Access Compliance Report

Public Rights-of-Way

(Curb Ramps)

Intersection ID: 12170	Main Street: S_POPLAR_ST	Cross Street: W_4TH_ST	Location: S
ADA ID: 47D2147405A9	Ramp Type: PerpDiag	Initial Pass/Fail: Fail	Overall Compliance: No
Severity Score: 22.5			
Codes/Mitigation Info/Possible Solution		Field Measurements/Component Compliance

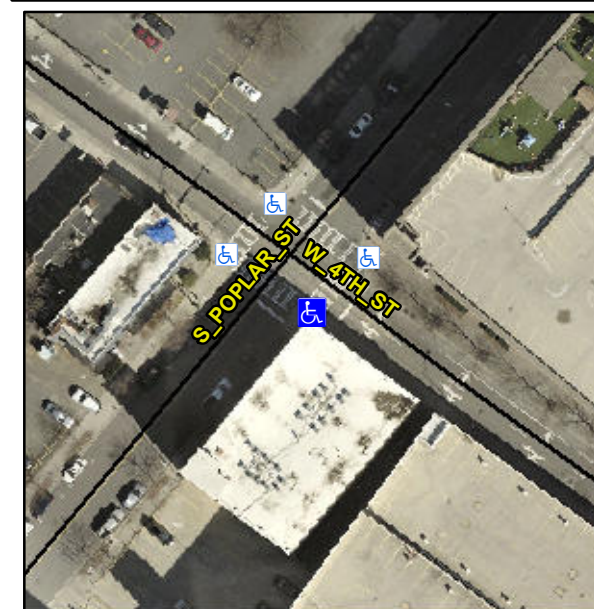
Not Found, R304.5.1, R304.2.2

Compliance	Description	Data	Compliance	Description	Data
N/A	Ramp Length (in)	68.0	No	Ramp Slope (%)	8.9
No	Ramp Width (in)	45.5	Yes	Ramp XSlope (%)	2.3
N/A	Flare Type LT	N/A	N/A	Flare Type RT	N/A
N/A	Flare Slope LT (%)	N/A	N/A	Flare Slope RT (%)	N/A
N/A	Flare Traversable LT?	N/A	N/A	Flare Traversable RT?	N/A
N/A	Landing Length (in)	N/A	N/A	DWS Provided?	N/A
N/A	Landing Width (in)	N/A	N/A	DWS Contrast?	N/A
N/A	Landing Slope (%)	N/A	N/A	DWS Length (in)	N/A
N/A	Landing X Slope (%)	N/A	N/A	DWS Full Width?	N/A
N/A	Landing Curb? (Y/N)	N/A	N/A	DWS Offset (in)	N/A
N/A	Shared Landing?	N/A			
N/A	Gutter Ponding?	N/A	N/A	Gutter Slope (%)	N/A
N/A	Gutter Lip Ht (in)	N/A	N/A	Gutter X Slope (%)	N/A
N/A	Painted X Walk1?	Yes	N/A	Painted X Walk2?	Yes
	X Walk 1 Direction	To NE		X Walk 2 Direction	To NW
N/A	X Walk 1 Width (in)	113.0	N/A	X Walk 2 Width (in)	113.0
	X Walk 1 Slope (%)	5.4		X Walk 2 Slope (%)	1.7
	X Walk 1 X Slope (%)	1.5		X Walk 2 X Slope (%)	4.7

Remove & Replace Curb Ramp With Two New Directional Ramps or Equivalent.
